Re: **Wire Fence CANYON* *Federal* ~~Utah~~ *21-1*
Burton/Hawks, Inc.
4-Well Program
South Uinta Prospect
Duchesne County, Utah

WIRE FENCE CANYON

TO: DISTRICT ENGINEER, O&G, SALT LAKE CITY, UTAH
SUBJECT: APD MINERAL EVALUATION REPORT
OPERATOR: Burton/Hawks, Inc.
LEASE NO. U-8895
WELL NO. No 21-1 Wire Fence Canyon - Fed
LOCATION: 1/2 NW 1/2 NE 1/2 sec. 21, T. 6S, R. 5W, USM
Duchesne County, Utah

No. 21-1 Wire Fence Canyon-Federal
NWNE Section 21, T6S, R5W
Duchesne County, Utah
U-8895

ACCESS ROAD MAP

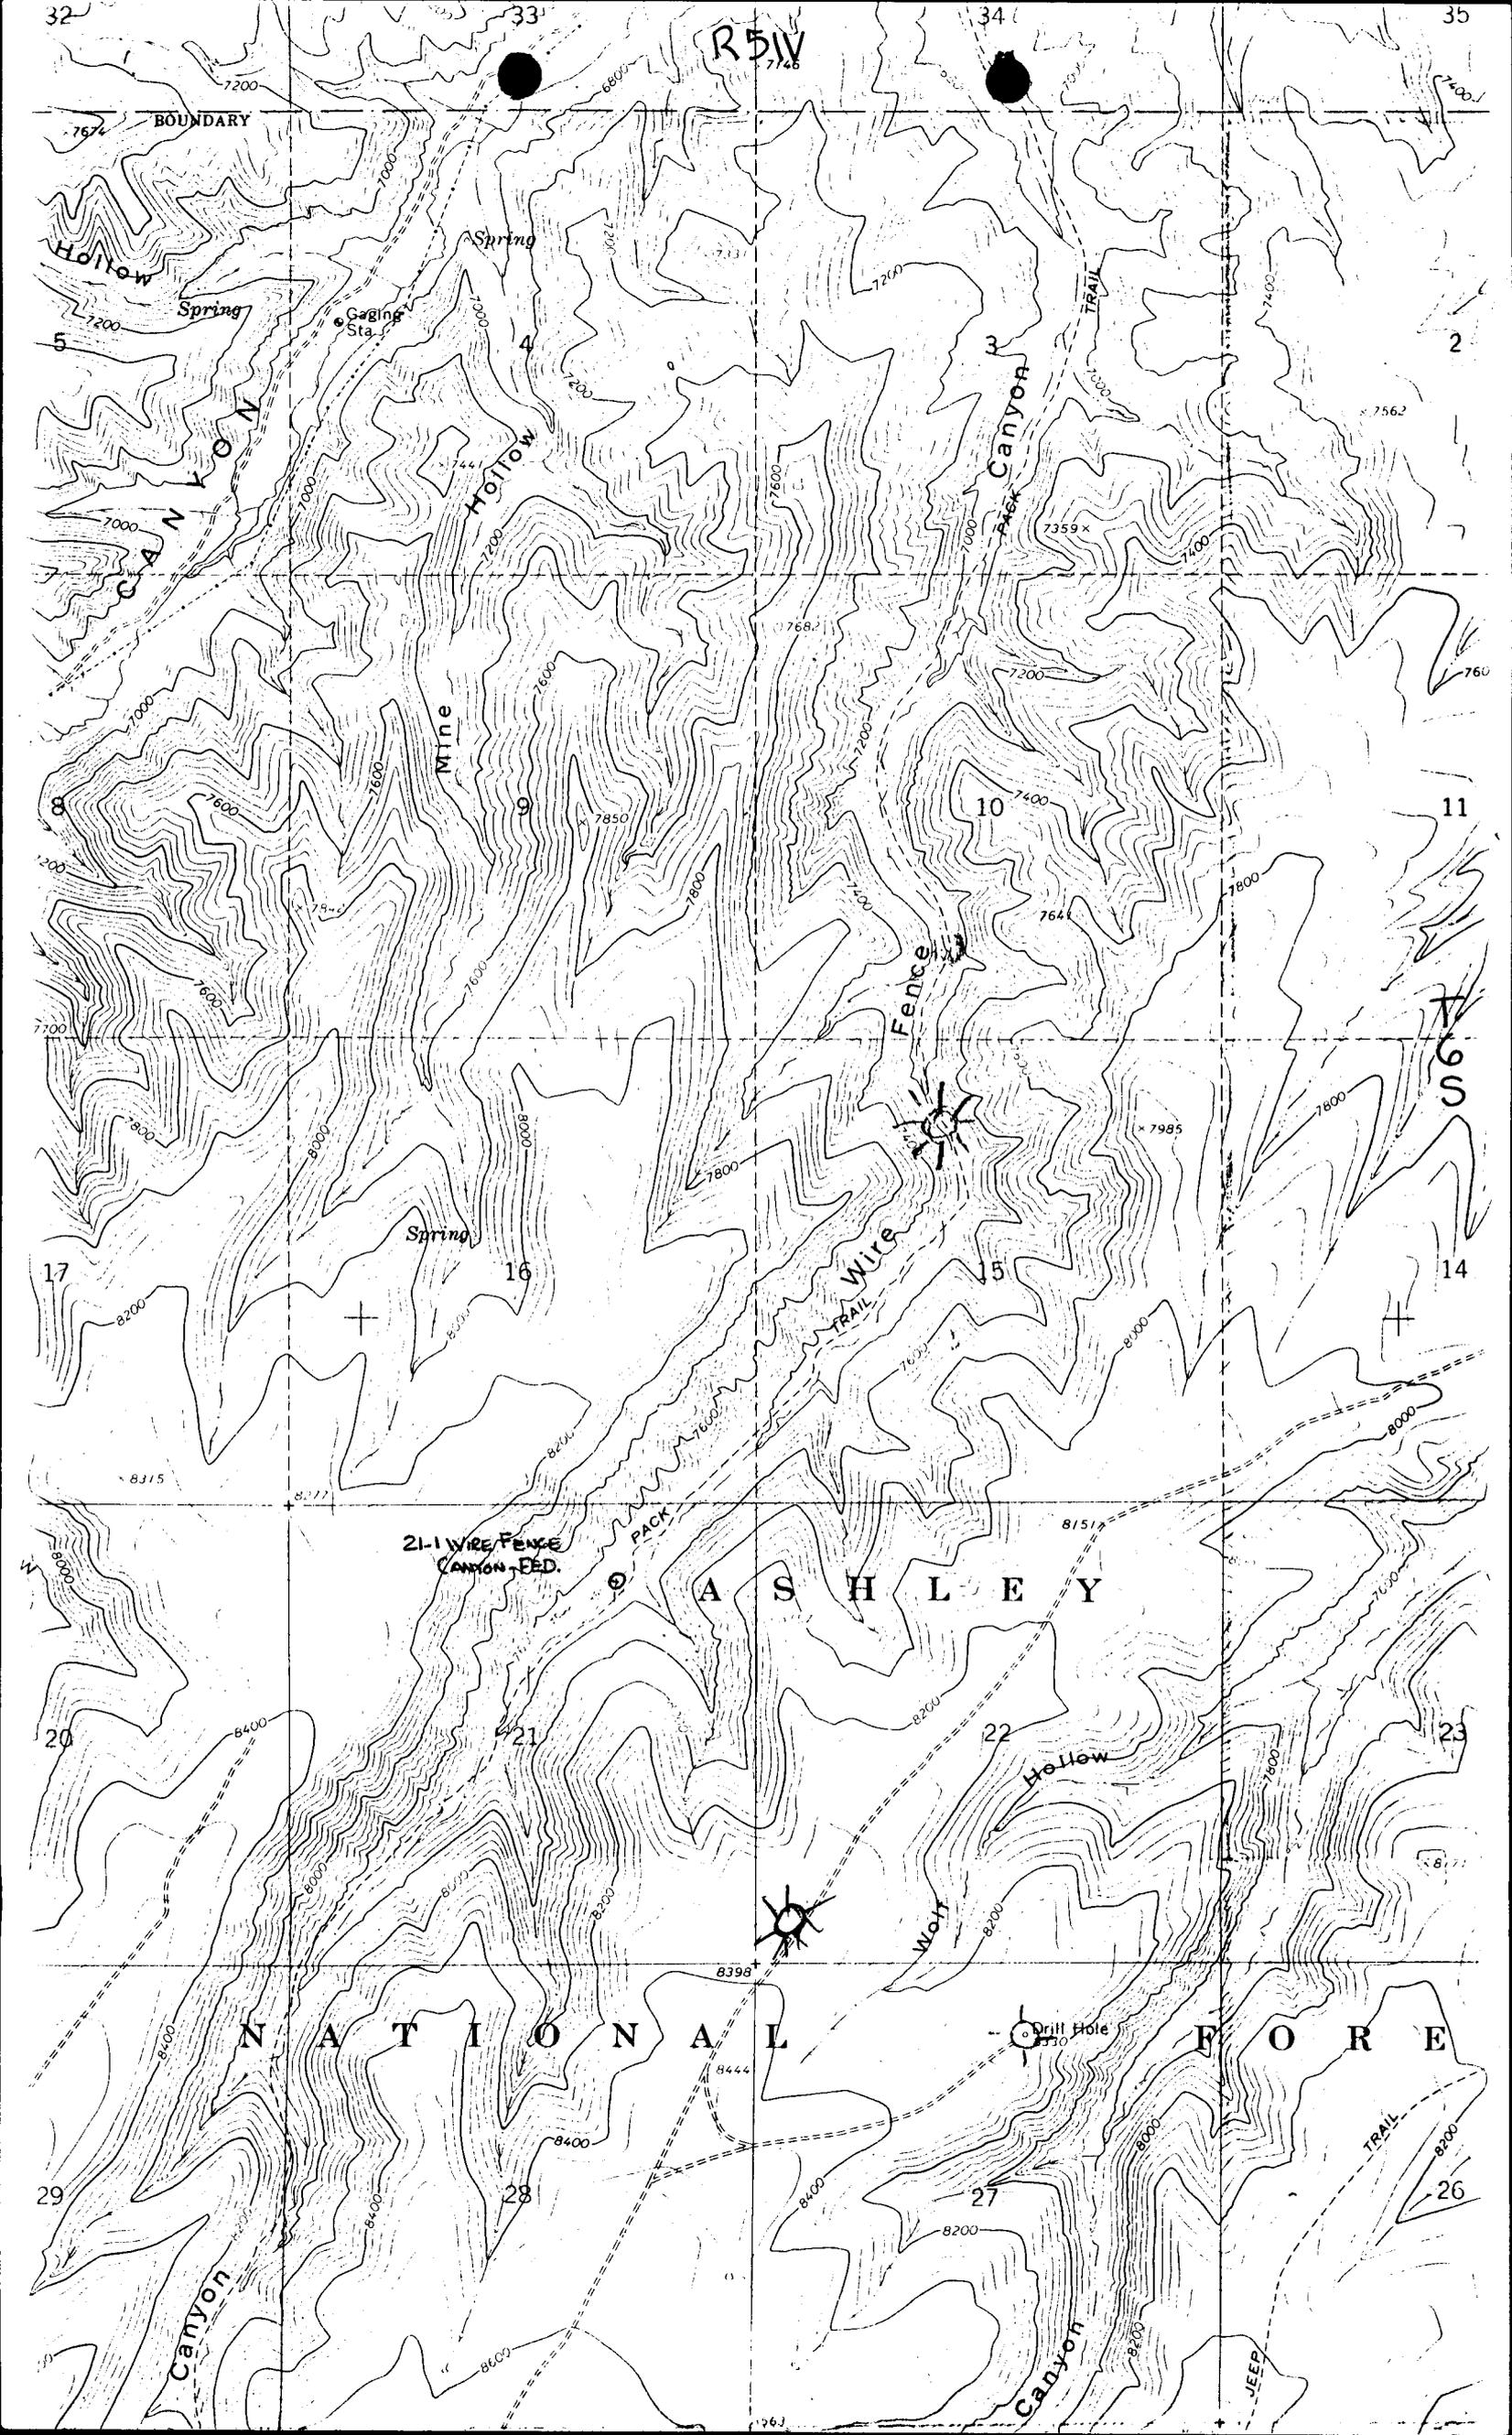
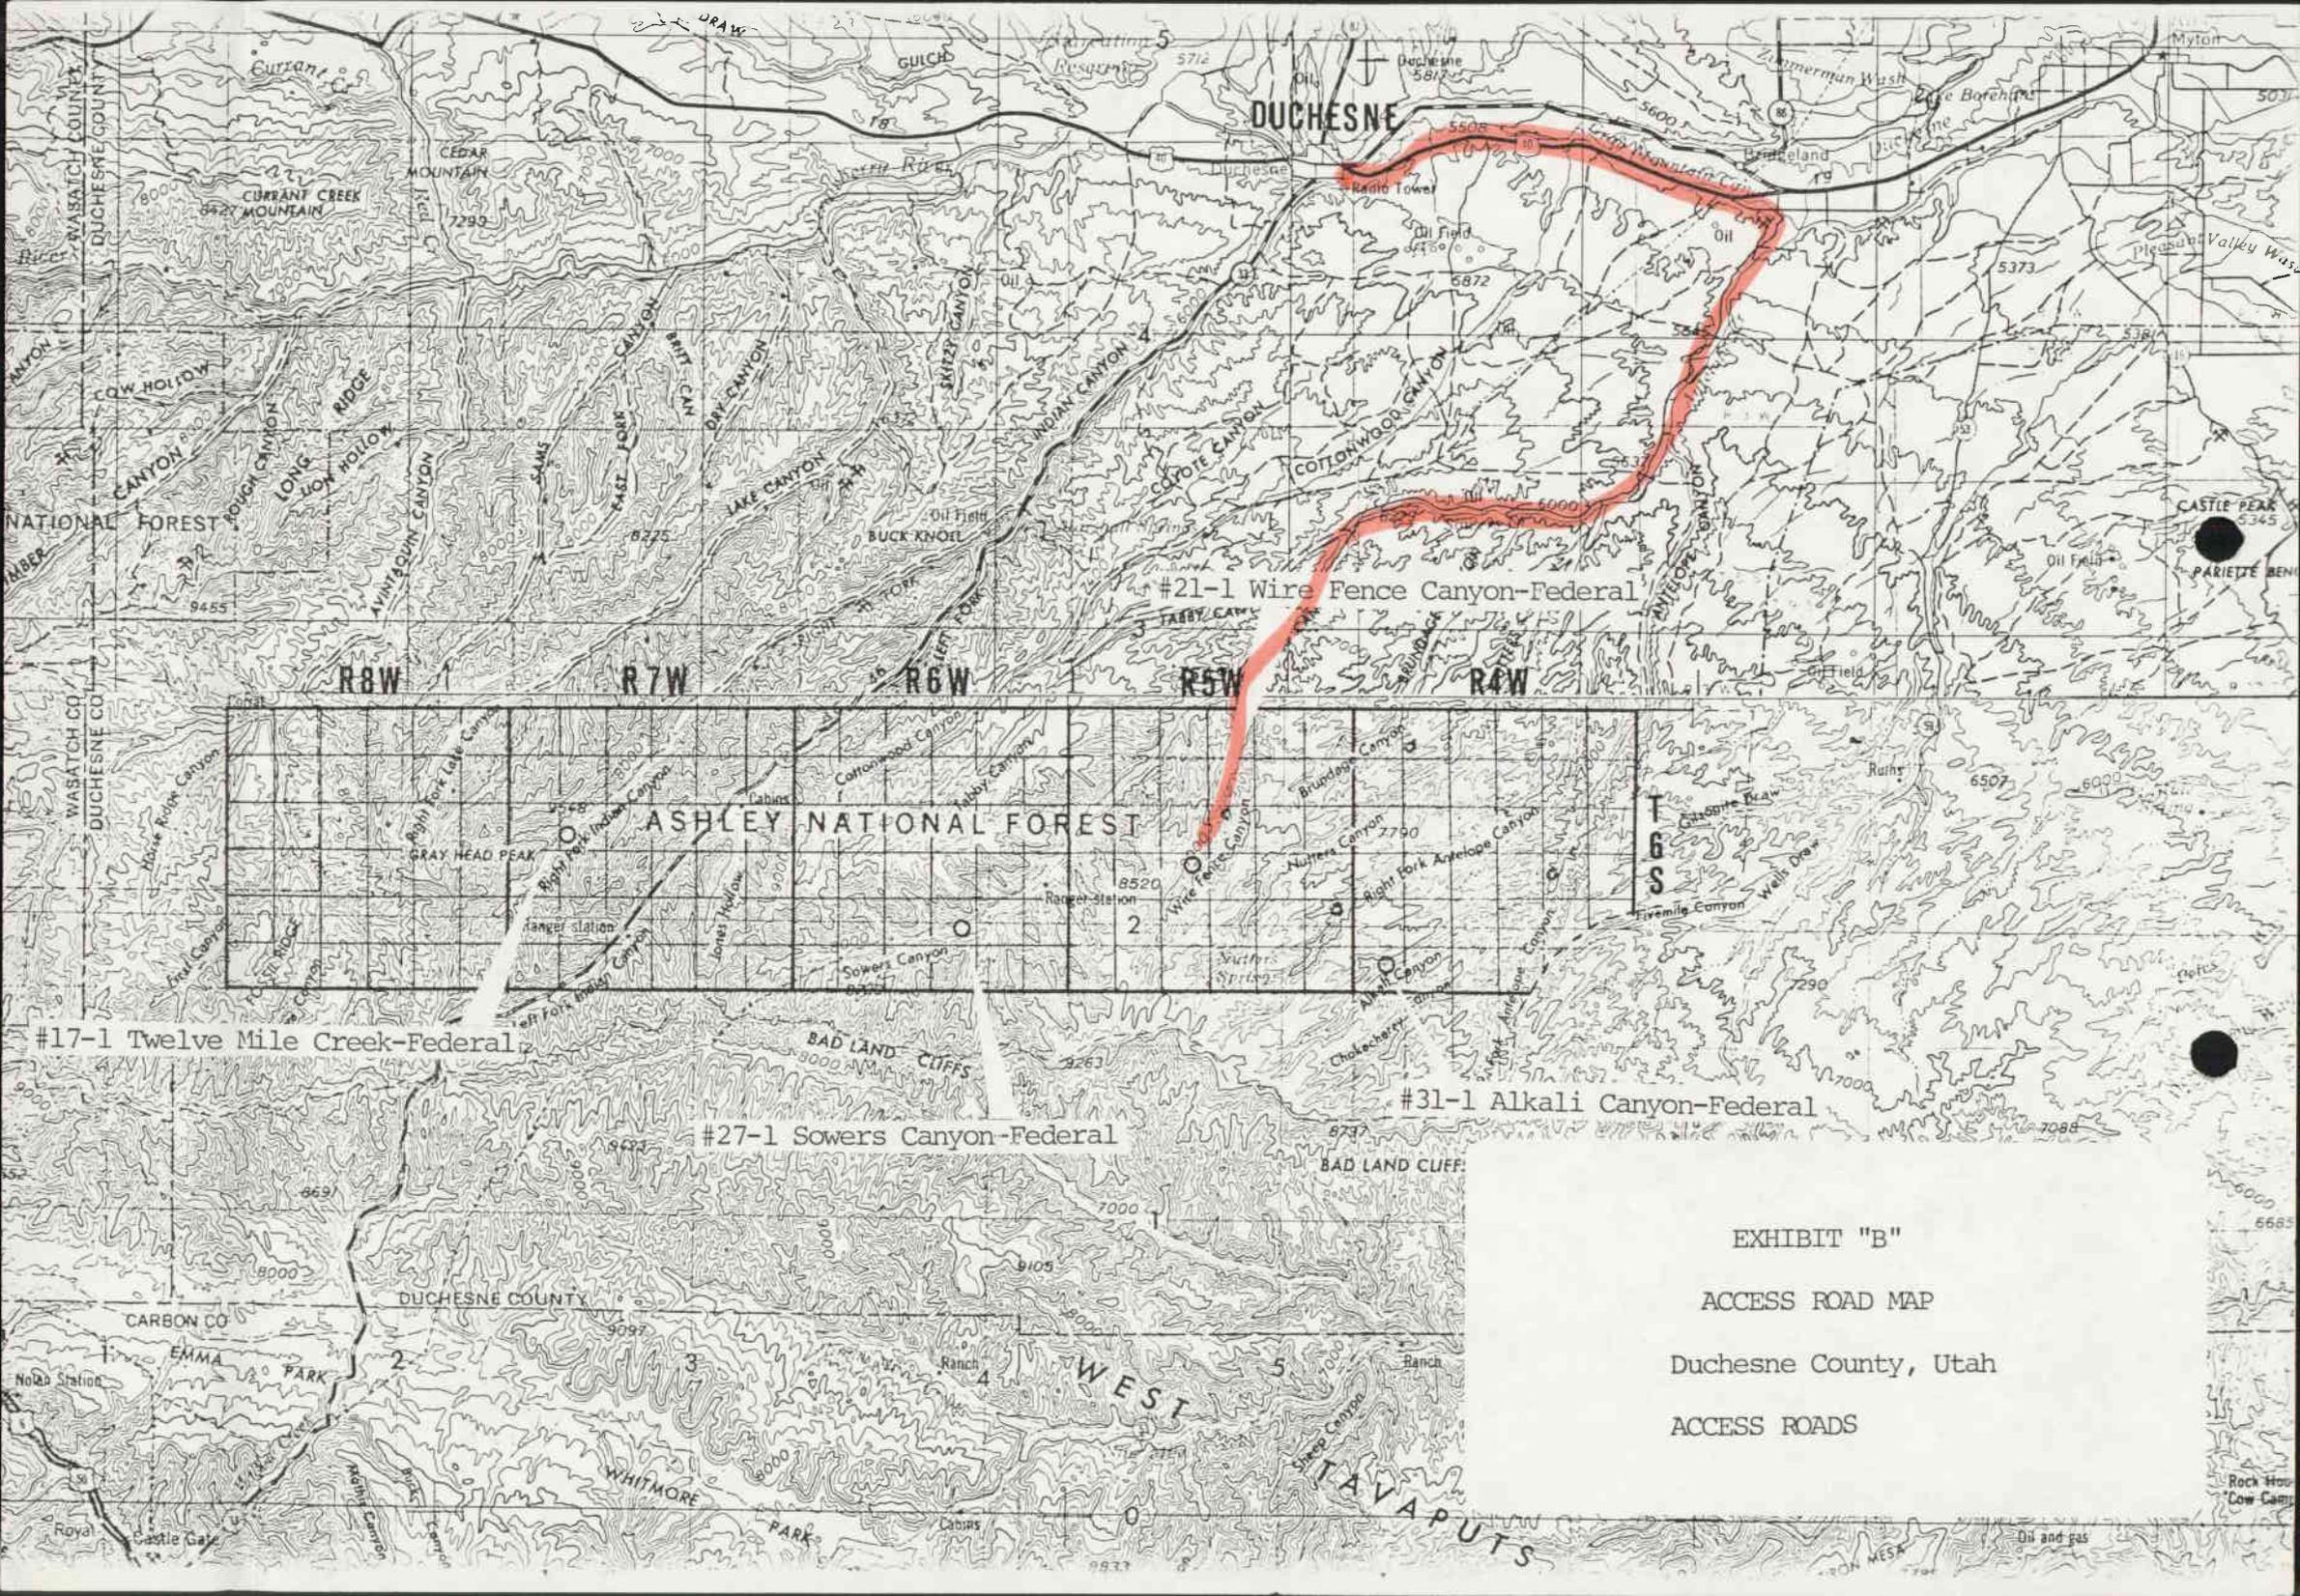
2. ^{WIRE FENCE CANYON} Both ~~Anthro-Mtn. Fed. 21-1~~ and Alkali Canyon Fed. 31-1 require extension of existing roads. We would prefer to work with their surveyors to flag the access routes prior to surveying and staking.

3. ^{NW NE} Access to ~~Alkali Canyon Fed. 31-1~~ ²⁴ requires crossing private land. We suggest an approved agreement between Burton/Hawks and the private landowner be submitted with the operating plan. This agreement should include access for exploratory drilling, partial and/or total restoration and operation-maintenance requirements.

5. ^{WIRE FENCE CANYON} ~~Anthro-Mtn. Fed. 21-1~~ is located in Wire Fence Canyon which is extremely narrow. A large grill pad will not fit the available space without cutting in the unstable side slopes. Depending on the size of pad, we are confident some modified drilling arrangements can be developed to permit drilling this location.
